SUBJECT: Response to Request for Additional Information Regarding Relief
Request No. RR-PR-01
Vermont Yankee Nuclear Power Station
Docket No. 50-271
License No. DPR-28

Vermont Yankee Nuclear Power Station
Response to Request for Additional Information

**REQUEST FOR ADDITIONAL INFORMATION FOR
RELIEF REQUEST NO. RR-PR-01
RELATED TO TESTING OF SERVICE WATER PUMPS
ENTERGY NUCLEAR OPERATIONS. INC.
VERMONT YANKEE NUCLEAR POWER STATION
DOCKET NO. 50-271**

OP 4181.01(Q) P-7-1C ΔP & Amperage

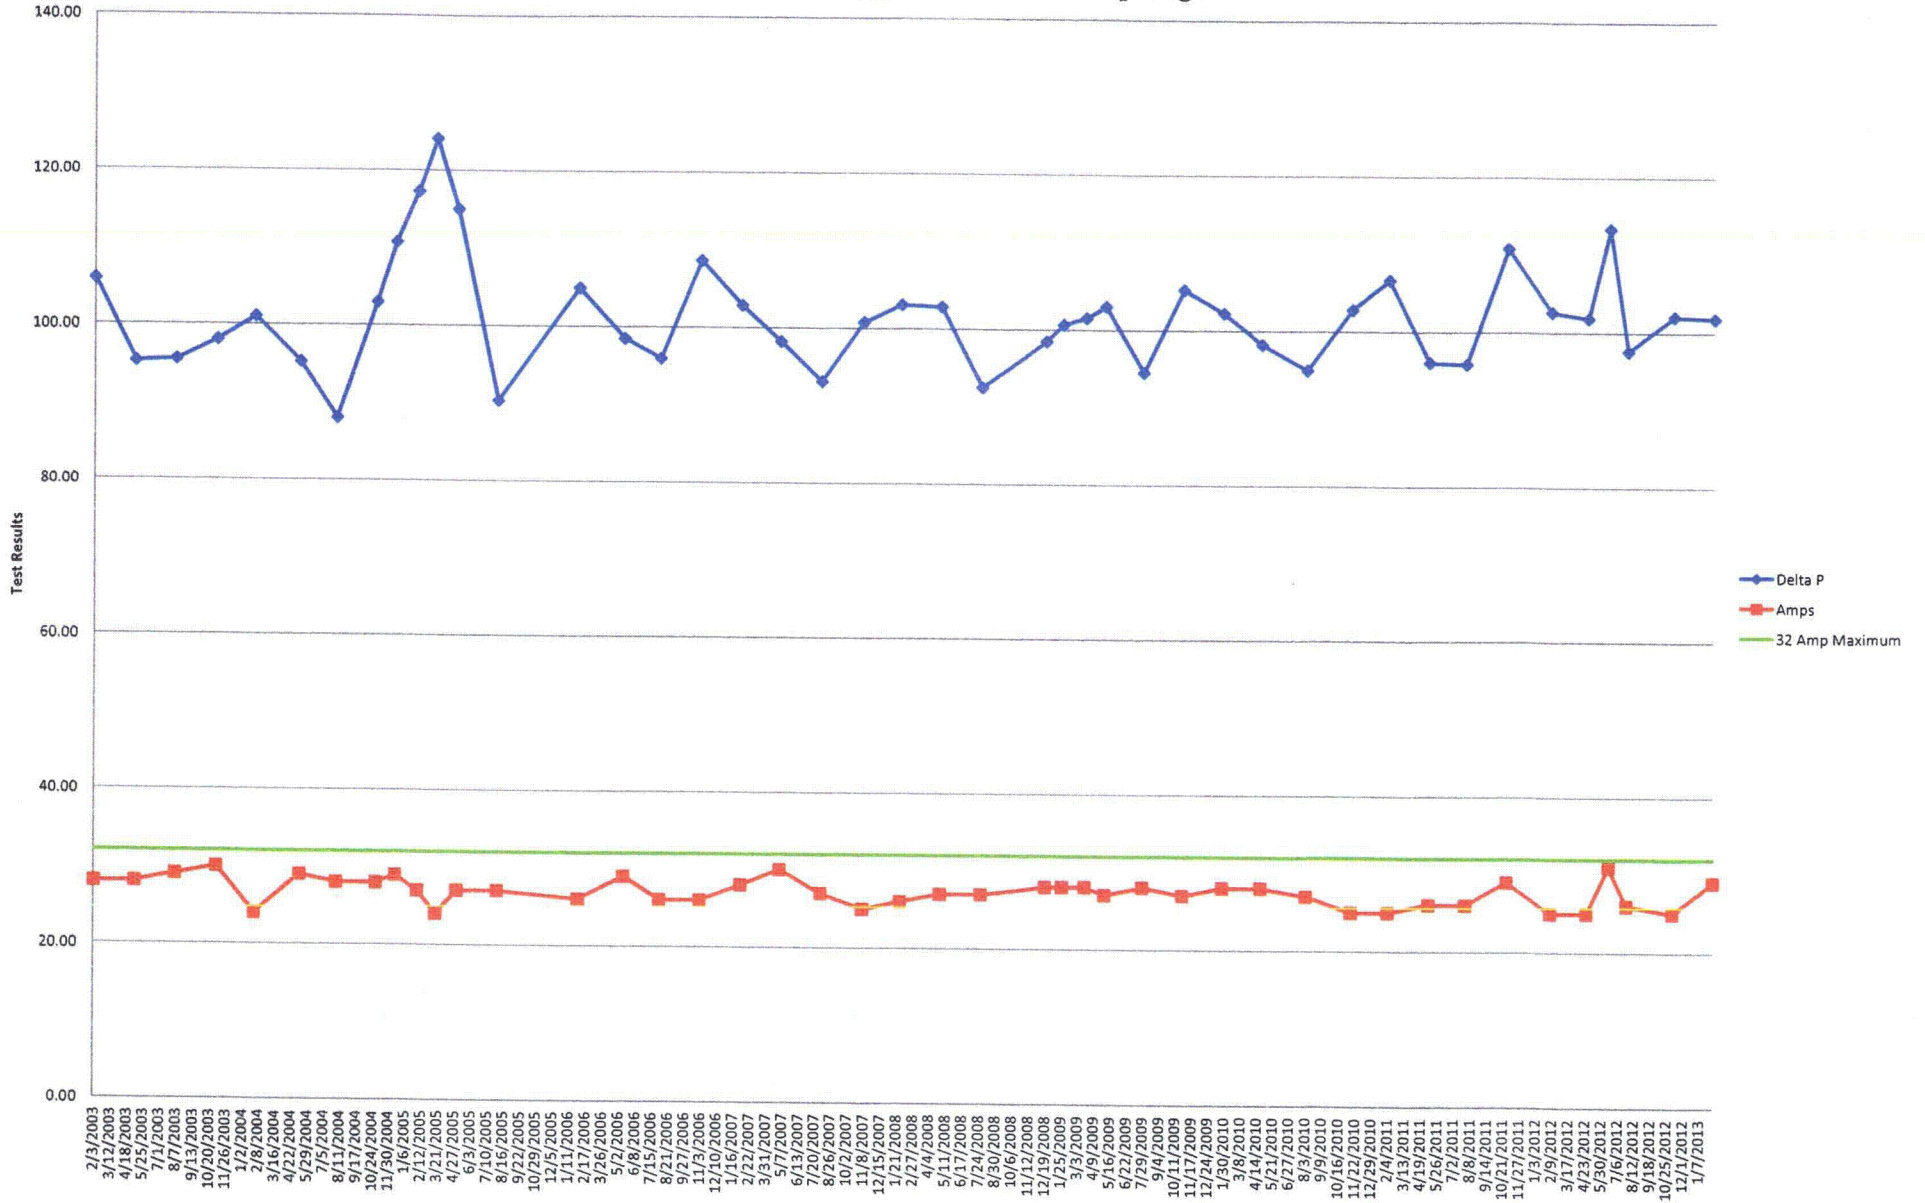
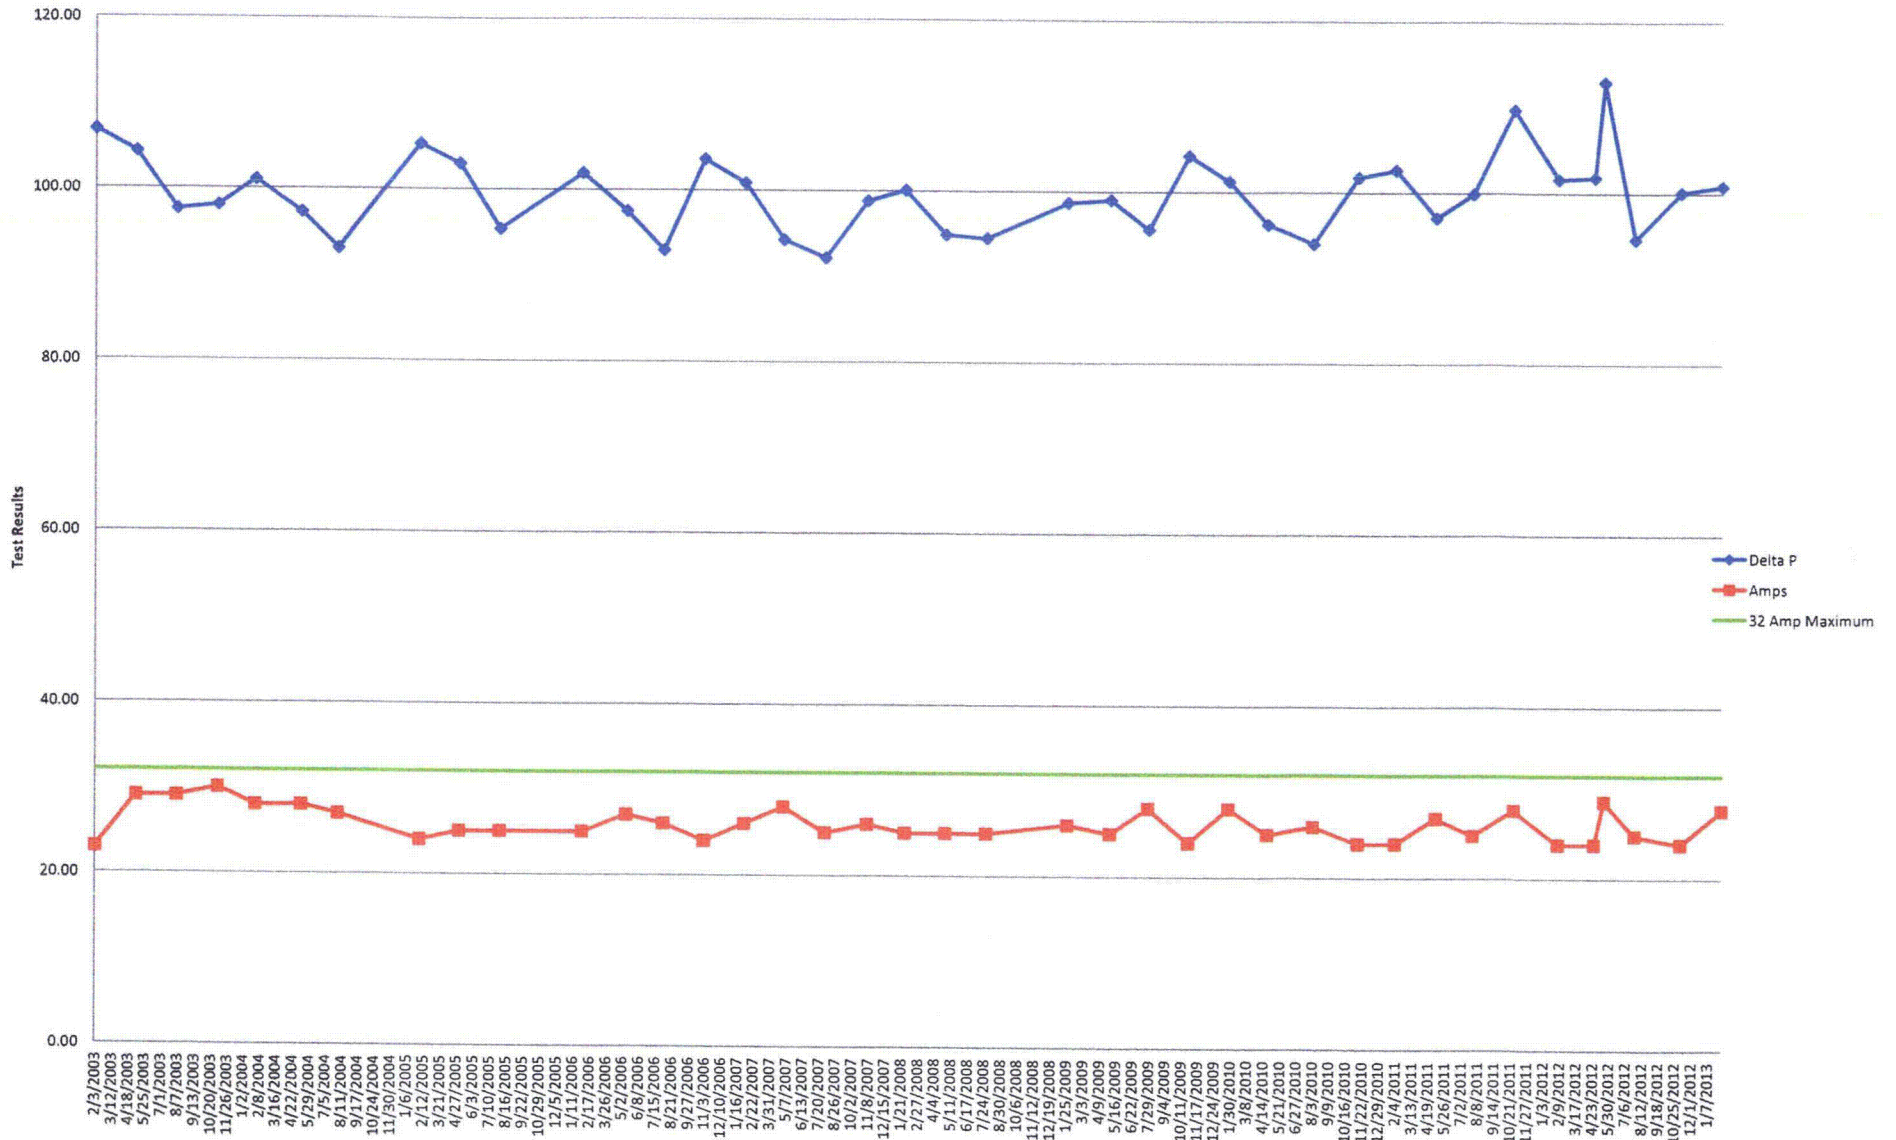
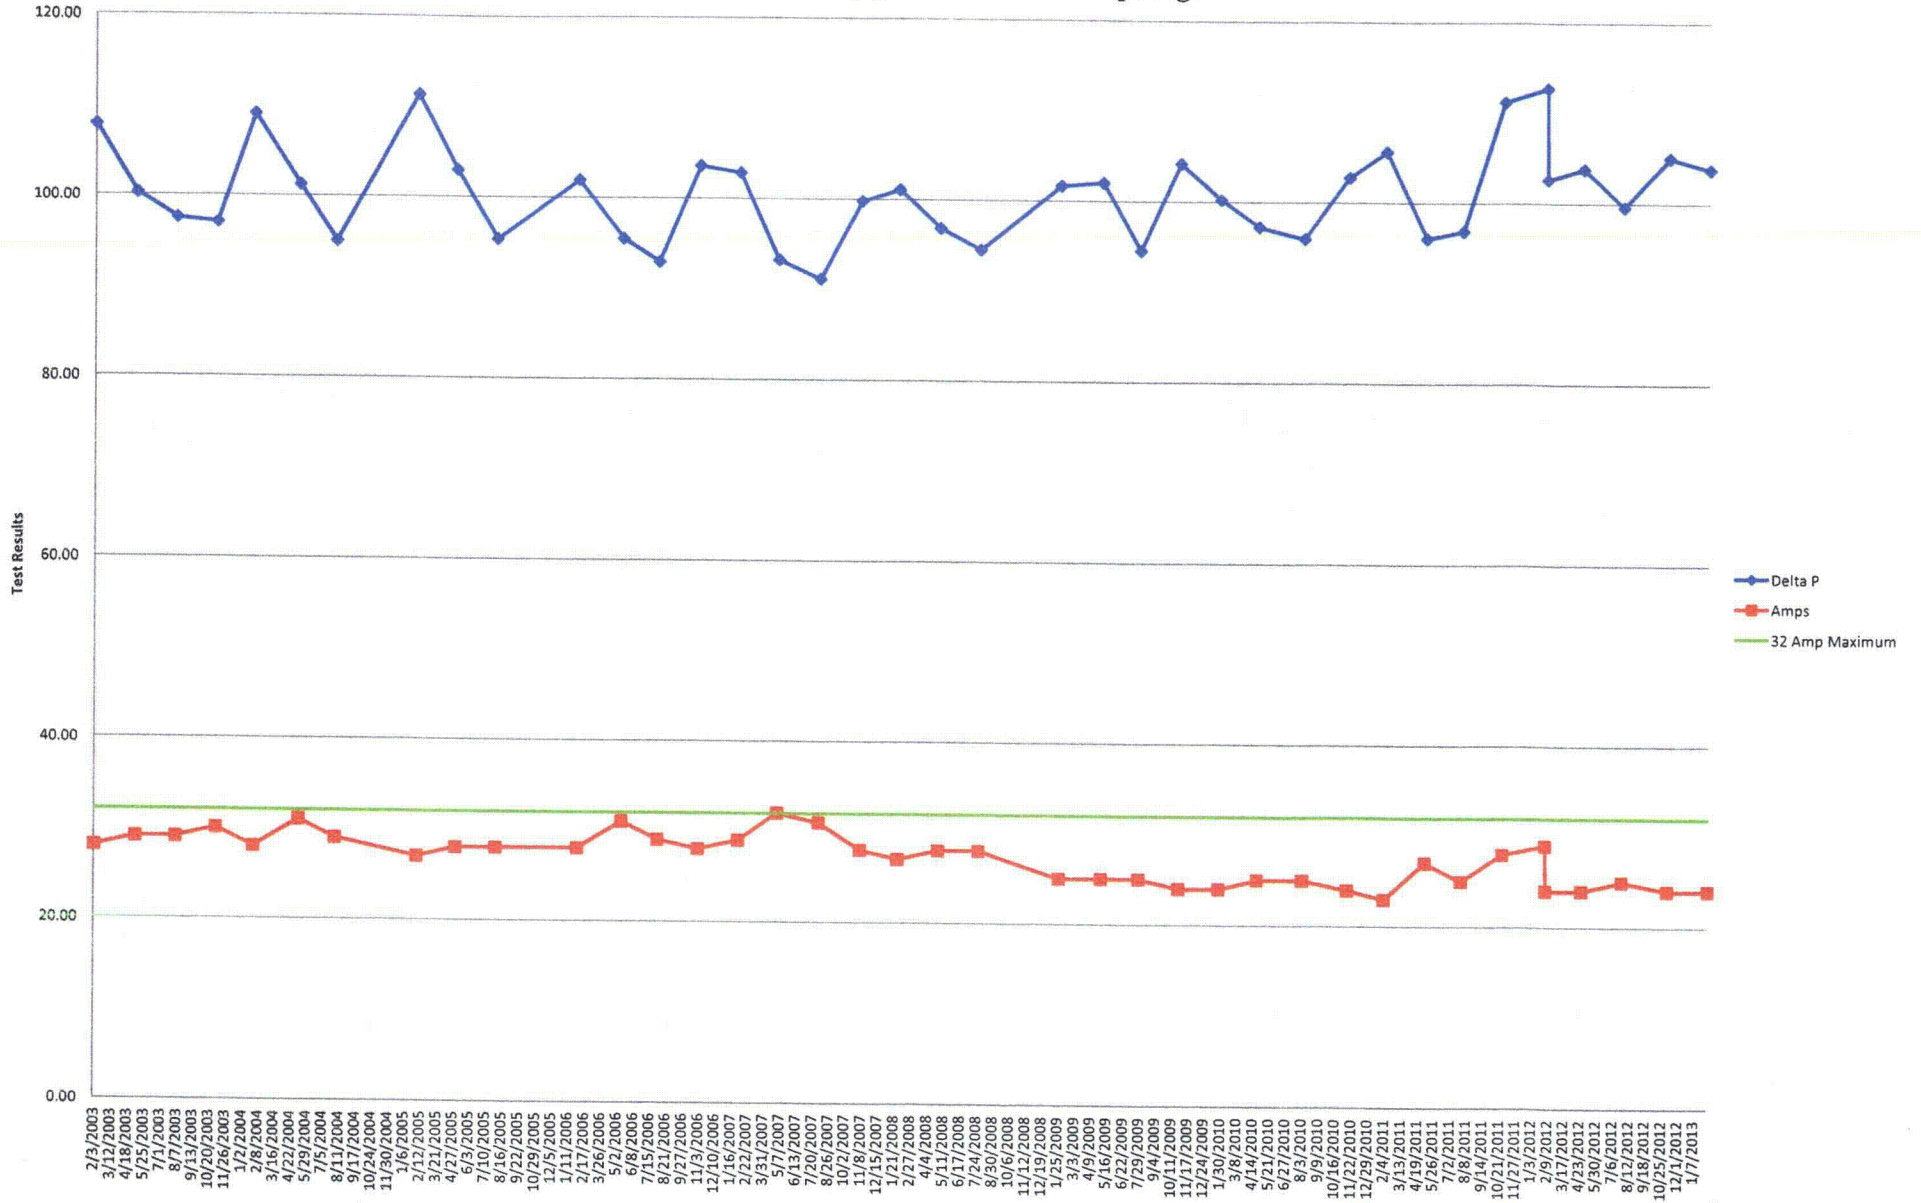
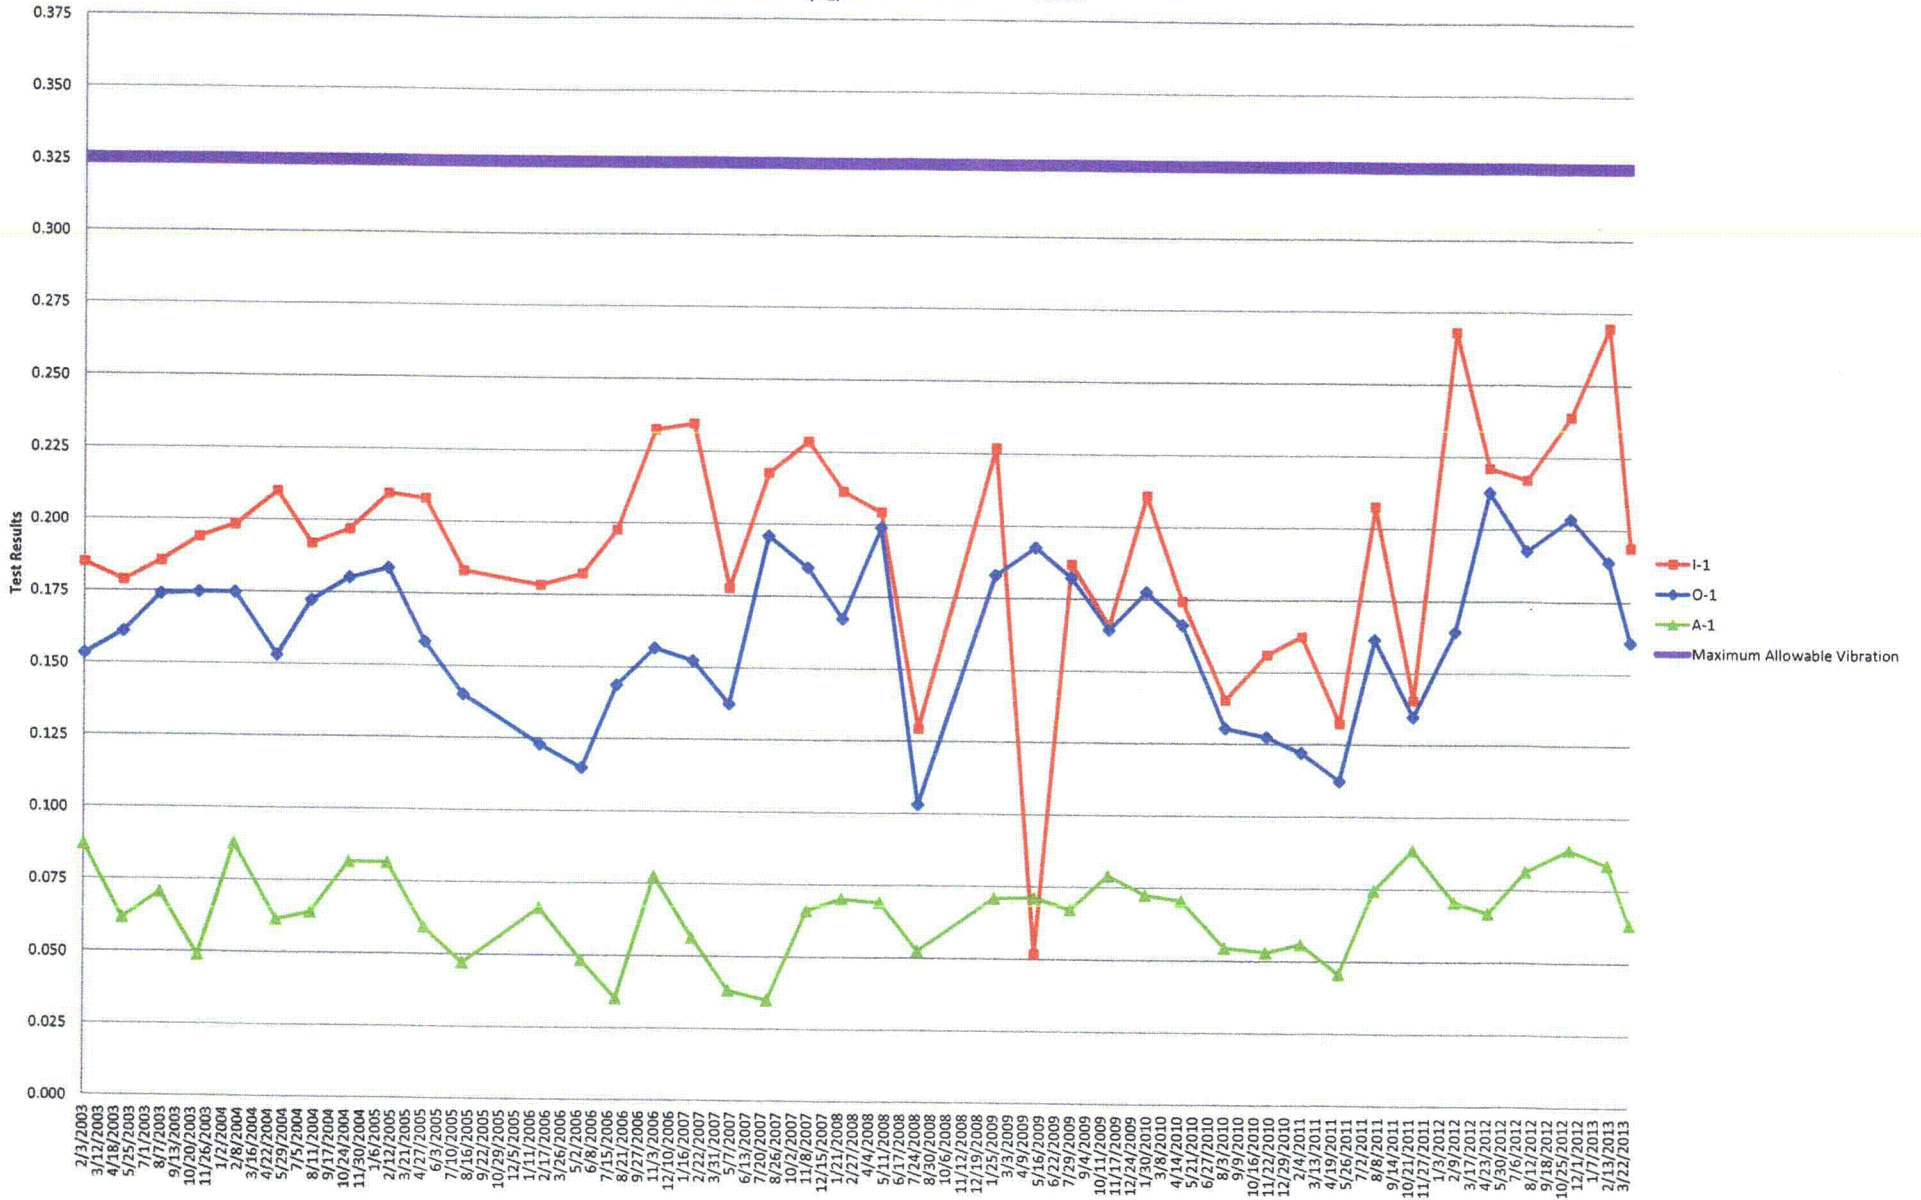
Please provide the inservice test data for the past 10 years for all of the service water pumps noted in this request.

The inservice test (IST) 5-point (capacity) test, quarterly d/p and amperage test, and quarterly pump vibration test data for the past 10 years for all of the Service Water pumps noted in the relief request are included in Attachment 2. Note that vibration data, which is taken at all 5 points during the 5-point test, is not included in capacity test results due to the volume of data.

1. Vibration test data is in units of inches per second. The .325"/sec. is generic OM Code Alert maximum, however point A-1 is approx. ½ of maximum.
2. The quarterly test data is from the IST trend database (original data transferred from completed test forms).
3. The 5-point test data is from the IST "set-up" validation spreadsheet (official data is contained in the completed test form). This data includes the scheduled RFO surveillance and lift adjustments.
